LTR-CDME-08-11, Rev. 3 NP-Attachment

Interim Alternate Repair Criterion (ARC) for Cracks in the Lower Region of the Tubesheet Expansion Zone

Response to NRC Request for Additional Information Relating to LTR-CDME-08-11, Rev. 3, NP-Attachment

QUESTIONS RELATING TO STEAM GENERATOR TUBESHEET AMENDMENT ON INTERIM ALTERNATE REPAIR CRITERIA

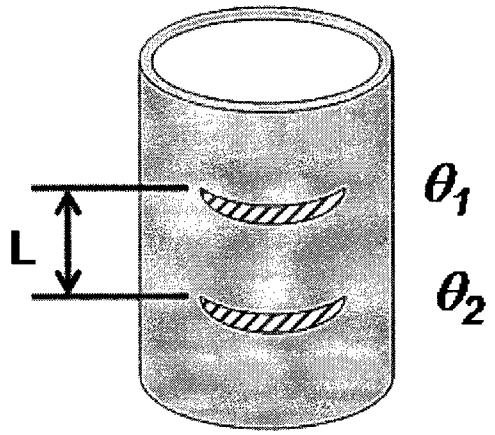
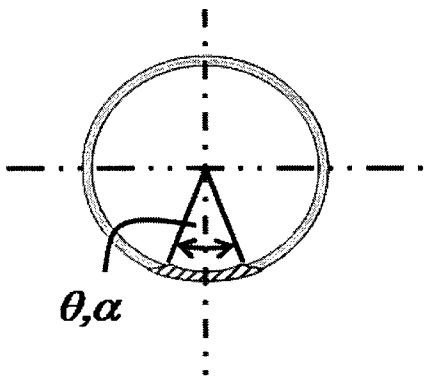
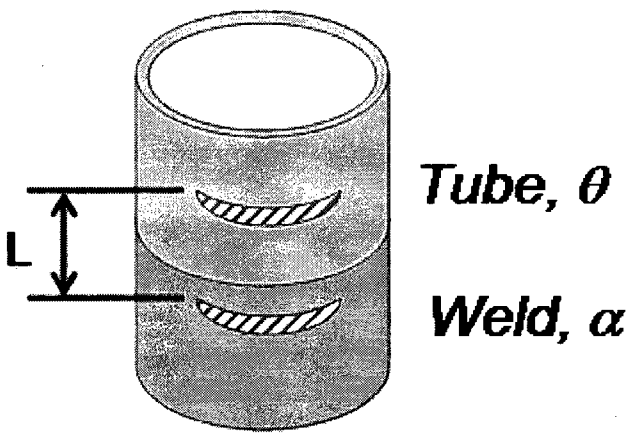
The impact of the crack separation analysis is summarized below. Refer to Figures 11-3 through 11-5 for explanations of the crack geometries and combinations of crack-like indications considered in the analysis. Table 11-1 is a summary of the text description of the crack separation analysis impacts. The details described in Table 11-1 apply only to the portion of the tube within the tubesheet 17 inches below the top of the tubesheet (TTS-17 inches).

6	Yes	$\theta_1+\theta_2+\theta_n+\alpha > 94$	*Possible Crack in Weld*	< 1.00[3]	Sum of total non-overlapping crack angle plus overlap angle greater than 94°. Cracks in weld and tube do interact. Plug Tube.

1. See Figures 11-3, 11-4 and 11-5 for tube crack angle and weld crack angle definition.
2. θ_n is the sum of any remaining crack angles after the first two crack-like indications. For example, the statement: $\theta_1+\theta_2+\theta_n \leq 203°$ is equivalent to writing: $\theta_1 + \theta_2 + \theta_3 + \ldots \leq 203°$.
3. Separation distance, L, is measured from the tube end.
